Attachment F

Submissions

Subject: Submission - D/2023/842 - 155 Mitchell Road ERSKINEVILLE NSW 2043 - Attention Jessica Symons

This document highlights impacts to 7 Metters Street (7MS), that we feel have been caused by the additional mass to site E on 155 Mitchell Road (155MR), Erskineville, which has been submitted twice under two concurrent applications (D/2023/842 & D/2015/966/G)

Figure 1. Overlooking concern from increased street wall condition to 7 Metters Street property. Please note the plan for 7MS has been updated to reflect the as built condition rather than initial DA scheme. Please note this highlights living space on north facing terrace.

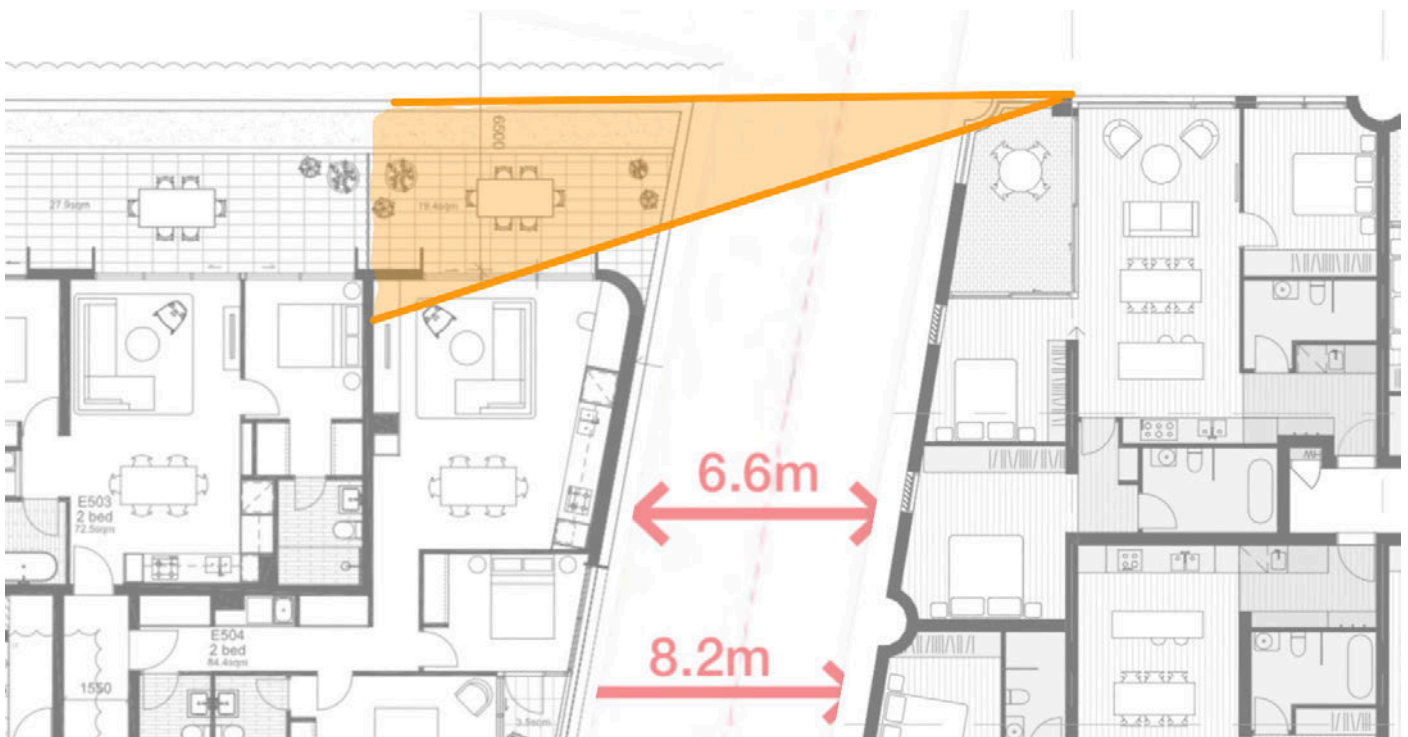
A greater street height has been added to 155MR when compared to the stage 01 scheme. These additions protrude beyond the stage 01 envelope and existing setback on the 7MS site, resulting in direct overlooking onto the balcony and into the living space of 7MS levels 5 and 6. The 155MR Stage 01 DA massing limited this issue to the terraces of level 5 7MS and level 5 115MR only.

Figure 2. Consented scheme - The 7 Metters Street has the level 5 terrace to match the stage 01 proposed for site E.

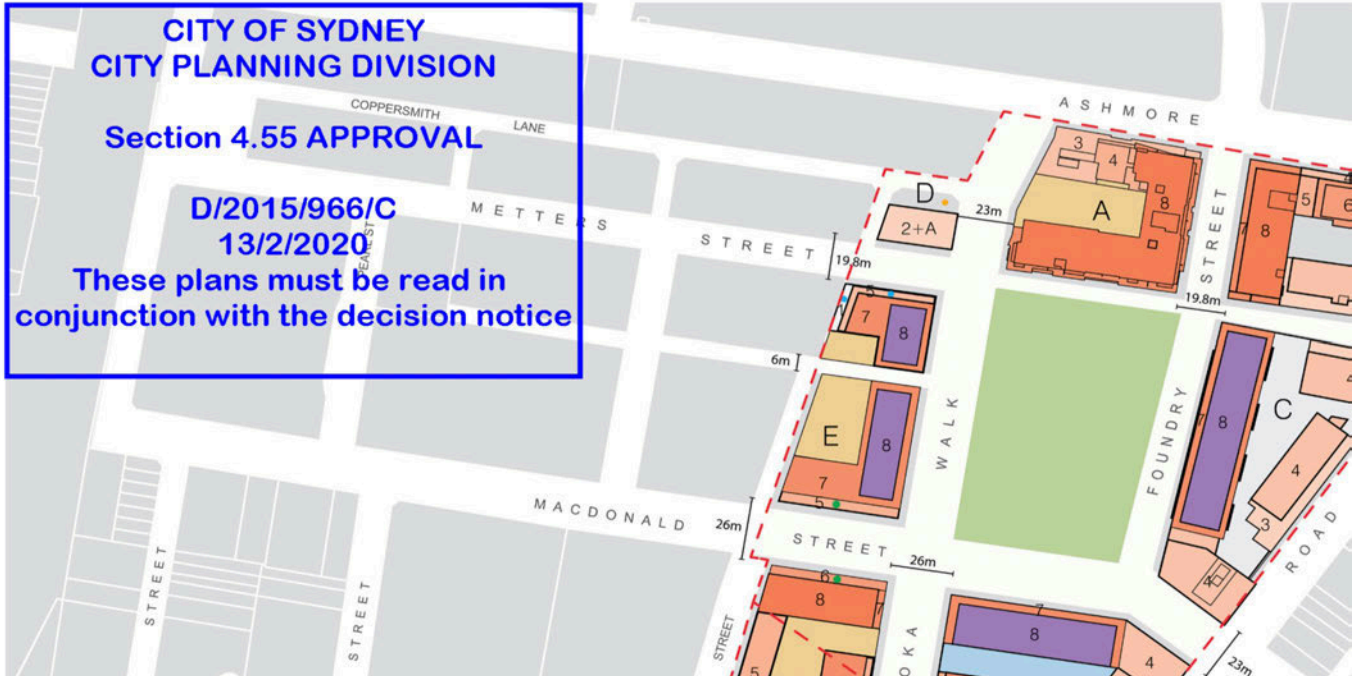
The figures below show the original stage 01 envelope and the new proposal. The applicant is seeking to substantially increase 155MR towards 7MS and the street, when the primary objective cited is to McPherson Park.

Figure 3. Amended scheme/application - The change to 7 story wall creates the overlooking.

Figure 4. Diagram highlighting massing changes - Street Wall condition

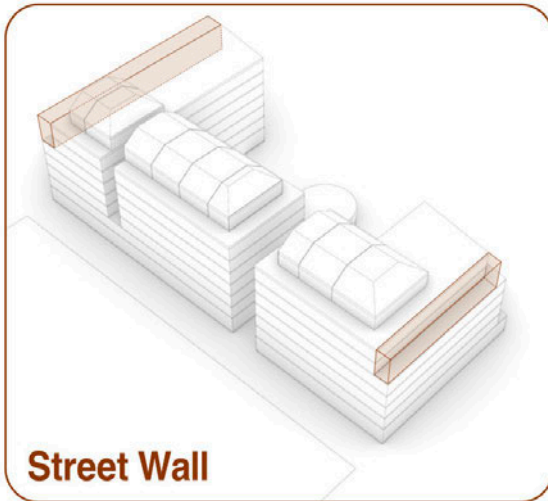
The diagrams below highlight the street wall increase and proposed open corner condition. These diagrams further reinforce the overlooking concern to the 7MS site caused by the forward position of the upper mass. Additionally, the open corners at 155MR Level 5 & 6 in the increased mass (adjacent neighbouring sites) are unscreened, causing the overlooking concern.

- Numerous atypical floor plates
- Narrow building depths to upper levels result in inefficiencies
- Street wall heights prioritised over park wall height

- Massing arrangement does not comply with the ADG intent
- Neighbouring building not built to comply with ADG separation
- Neighbour building includes direct facing balconies / living spaces

Figure 5. Diagram highlighting open corners - Privacy/overlooking concern

Refer to figure 8 for potential amendment to building incorporating setback and screening to 7MS

Figure 11. Potential setback to reduce privacy concerns

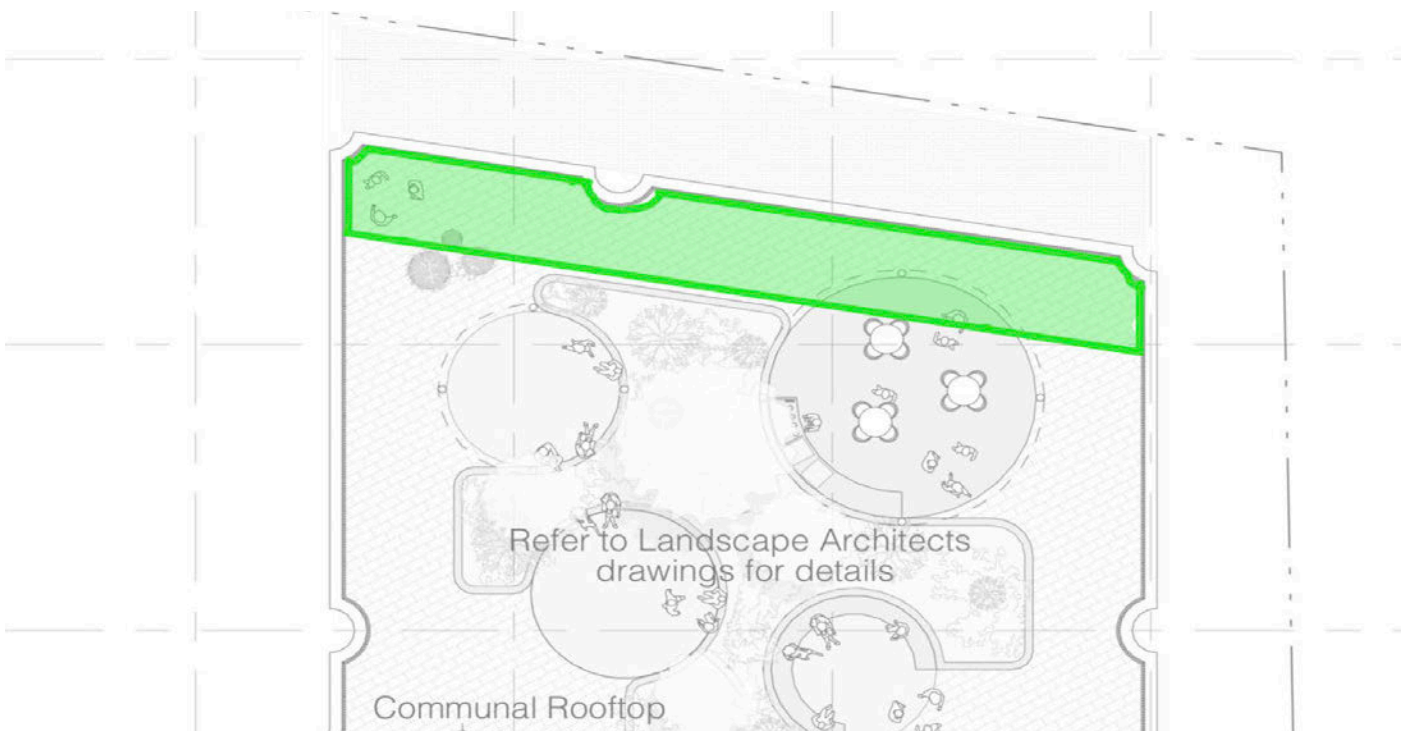
A new overlooking situation has been created by the shared amenity at the new roof level. The application seeks to use the terrace for communal functions on the site, introducing noise and visual privacy issues to 7MS' habitable spaces.

Figures 11, 12 & 13 show potential amendment to include sufficient setback and physical barrier.

CONCEPT DA D/2015/966/G

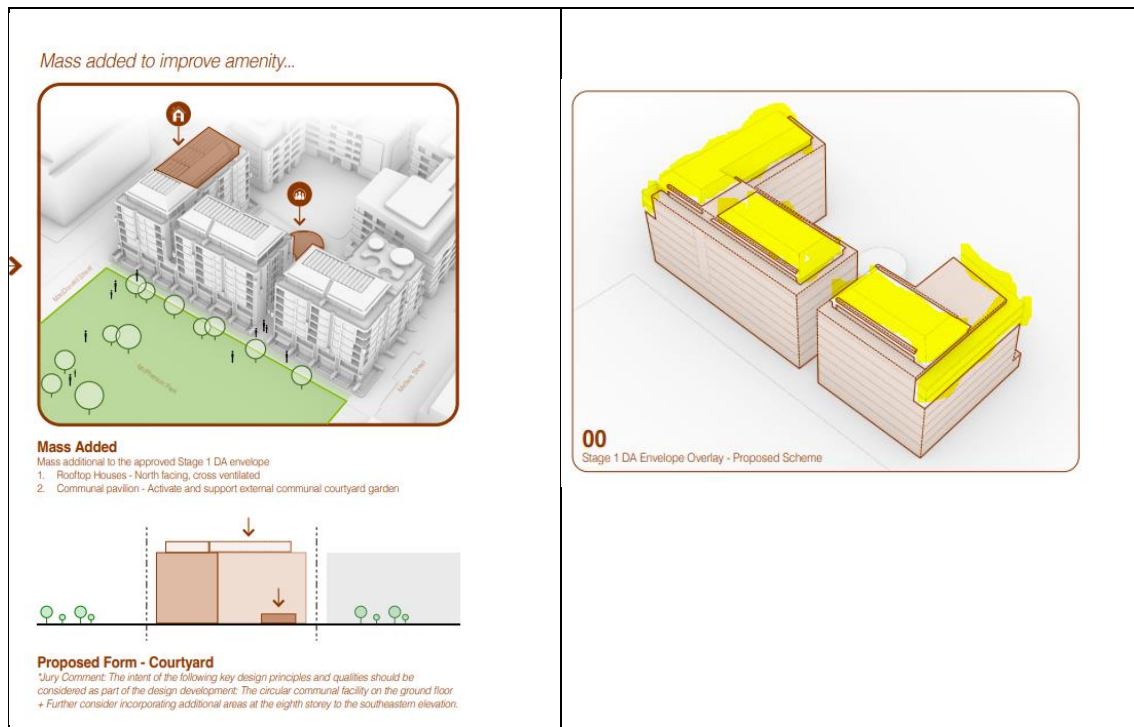
Street wall height increase from 5 to 7 storeys

- The additional street wall height is an arbitrary application, not considering the scale and grain of the neighbourhood. The predominant scale of Macdonald Street is five storeys, with additional height set back from the street wall.
- The application reports have no consideration of the street wall height and rhythm of Macdonald Street. The context of the neighbourhood is completely ignored.
- There are overshadowing impacts increased in the morning to the west and afternoon to the east, including additional overshadowing of the proposed McPherson Park.
- The density of the neighbourhood means enjoyment of public space, including streets and parks, is critical. Additional impacts to amenity because of increased bulk must be considered in this context.
- The Statement of Environmental Effects simply lists impacts, and does not justify them appropriately.

Concept:

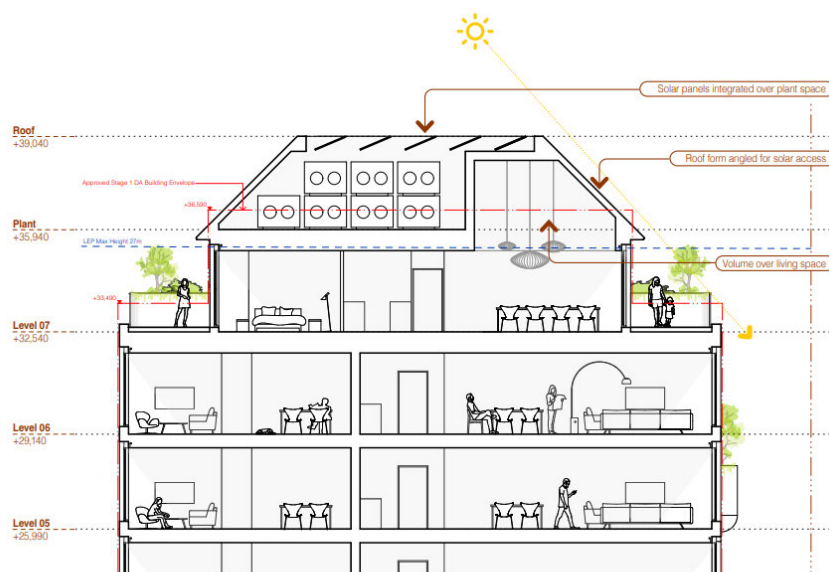
- Question viability of suspended trees, particularly those over communal lanes, with regard to wind, viability of growth, ongoing increase in weight as tree matures, resultant maintenance and appearance. A simpler design approach would be more suitable to the functional aesthetic of Erskineville.
- The scale of roof levels and the obtrusive mansard is inconsistent with the character of Erko. The raked roof is dominating and detracts from the simple character of residential apartment buildings within the locality. A simpler design approach would be more suitable to the functional aesthetic of Erskineville.

- The proposal seeks to preference amenity for its own residents to the detriment of the broader neighbourhood. A more communal consideration of amenity, and applying a less selfish design approach would help to provide a basis for reduced bulk consistent with the approved concept plans.

Transition of Building Heights' in Section 5.5.2 of the DCP:

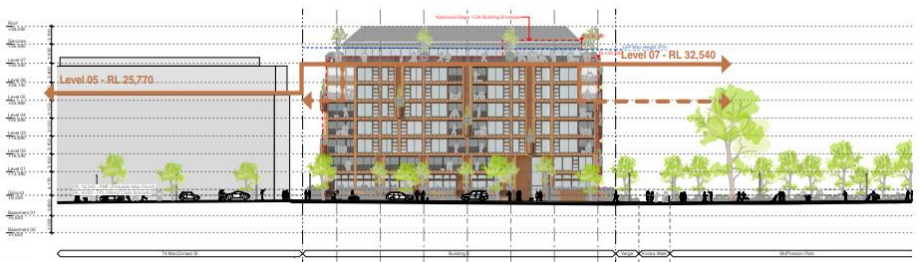
It is proposed to vary the Stage 1 DA envelope by prioritising the park frontage building height rather than the secondary streets. The resulting form provides a clear marker to the public park. This approach aligns with the intent of the urban design principle of:

Along MacDonald Street it can be seen in the adjacent diagram that the Stage 1 DA envelope generally aligned with the adjacent building street wall. It should be noted that the approved Stage 1 DA envelope does not nominate any RL for these side street walls relying only on a number of storeys. As such, it could be viewed that some flexibility exists to vary these street wall heights.
